Chaparral Resources, L.L.C.

Re: Packer Depth Exception Request
Lease Name: Houston "A"
Well No.: 1
API No.: 30-025-07202
Injection Permit No.: SWD 576
Location: Unit Letter L, Section 19-T12S-R38E
Lea County, New Mexico

From: David Spencer [david.spencer@chaparralenergy.com]
Sent: Thursday, October 27, 2011 3:26 PM
To: Jones, William V., EMNRD
Subject: FW: Chaparral Resources High Packer Setting Exception Request
Attachments: 20111027162150783.pdf

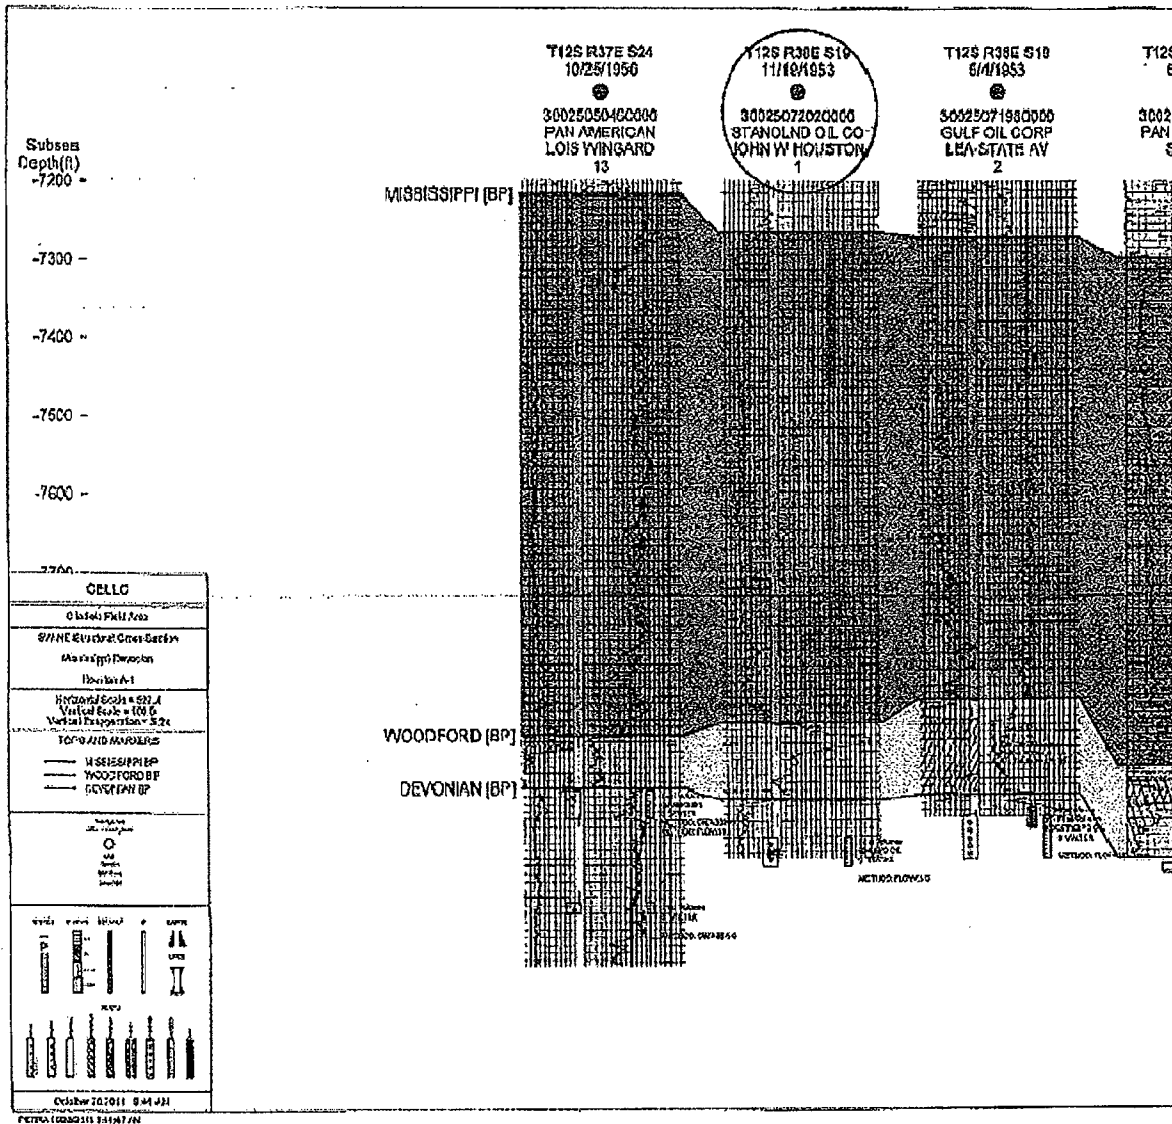
David - Attached is a scanned copy of a Cross-Section of several wells surrounding and including the John Houston #1 (2nd well from left to right), which I believe is also the #1A disposal well. The top of the Woodford/Base of Mississippi is at -7887 (measured depth of 11,771'). If the packer is set somewhere directly above that, it would be located in the lower Mississippi. Although the Houston #1A only has a gamma log, the surrounding Neutron logs would suggest there is no commercially producible hydrocarbons in this section of lower Mississippi. This section should contain primarily non porous and non permeable "tight" limestone and limey shales. As far as I am aware, the only productive Mississippi zones in the area would be from the upper Mississippi, 400'-600' above the base. This is reflected in the porosity zones you see at around -7500 and -7300' respectively. There is a porosity zone developed at -7688 to -7694 (measured depth of 11,573' to 11,579') in the southwest offset well (see cross-section) that may develop in the #1A. This zone would probably not be hydrocarbon bearing, but might produce water. Based on that, if the packer is set anywhere in the Mississippi below -7694 (measured depth of 11,579'), you should encounter only "tight" non porous limestone or shale.
